SUBJECT: Transmittal of Revised Westinghouse Proprietary and Non-Proprietary Responses to U.S. Nuclear Regulatory Commission Requests for Additional for the AP1000 Application for Design Certification

Westinghouse Revised Non-Proprietary Responses
to US Nuclear Regulatory Commission
Requests for Additional Information
dated March 17, 2003

AP1000 DESIGN CERTIFICATION REVIEW

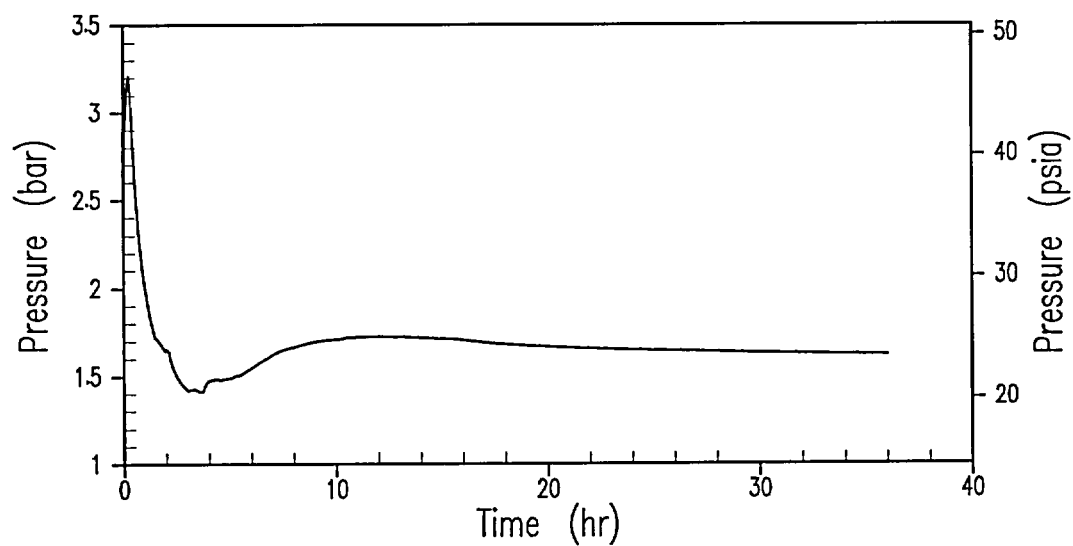
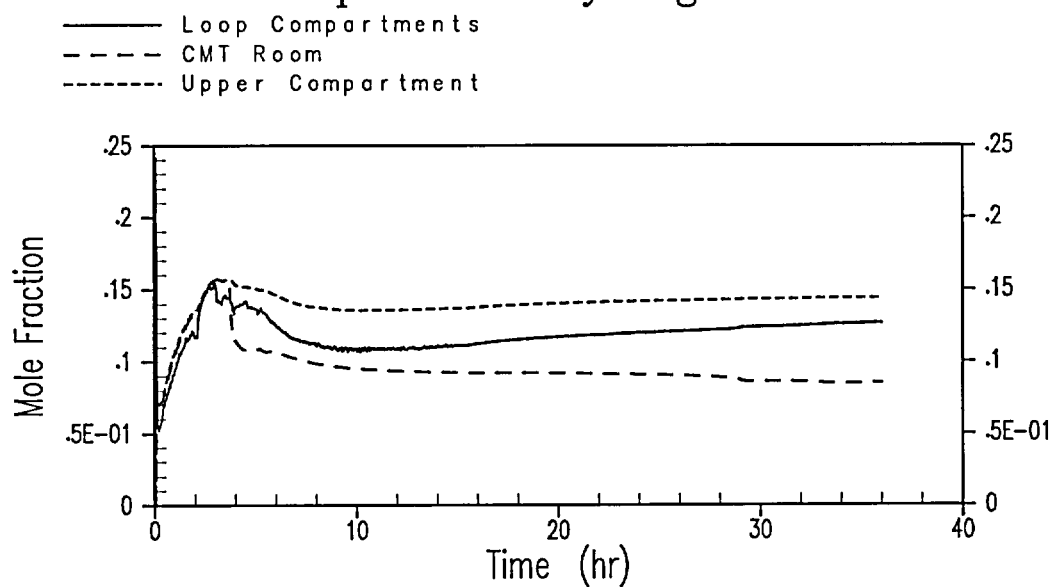
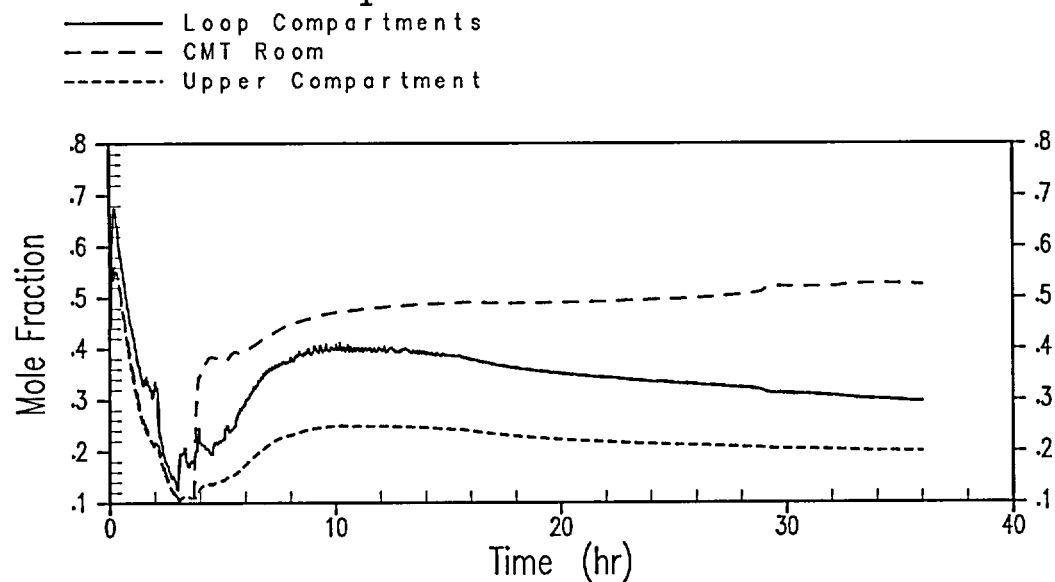
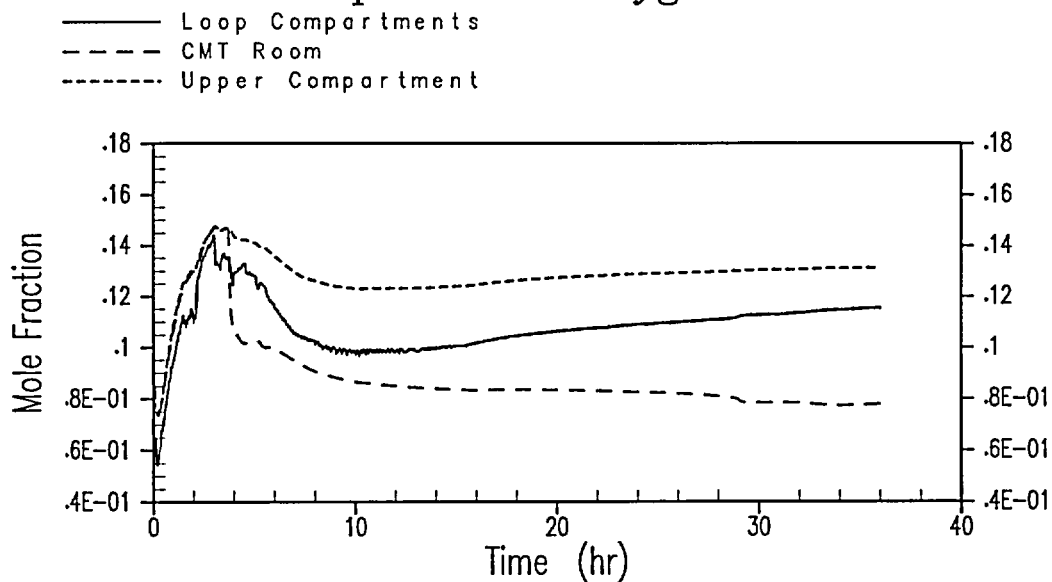
What are the mixture compositions within the AP1000 containment for a representative accident with 100% active cladding reaction throughout the entire sequence, including times beyond the intermediate time frame?

The mixture composition results from a MAAP4 analysis that produces more than 100% cladding reaction is attached to this RAI. The accident is assumed to be a 3BR sequence with MAAP4 modeling parameters set to artificially maximize hydrogen production. This is the same sequence that was used to produce the global hydrogen burn environment in the equipment survivability analysis. However, there is no hydrogen burning assumed to occur in the analysis presented here, so the mixture composition is representative of 100% cladding reaction throughout the sequence. The analysis is run to 36 hours, which is beyond the intermediate time frame. Note that because hydrogen generation is completed in the early time frame and containment pressure is stable, mixture compositions do not change significantly from the intermediate to late time frames. Therefore, considering hydrogen combustion in the intermediate time frame is conservative with respect to the timing of containment failure and offsite dose.
